Product / Process Change Notification (PCN)

PCN Number: PCN_ConBHD_20241129

Affected Series: WR-BHD

Before Change	After Change

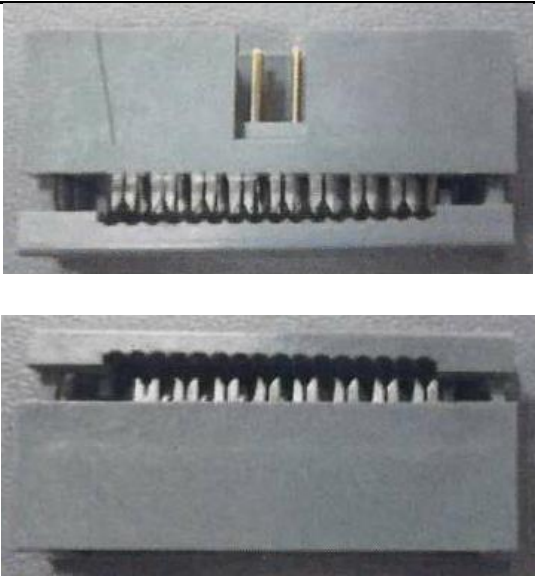
Due to external influences, Würth Elektronik eiSos will slightly change housing's color of serie 6120XX25821 and 6120XX25921 to improve supply chain of raw material. The base material remain the same, only color will change from light grey to dark grey.

Therefore, there will be no change in fit, function, quality or reliability of the product.
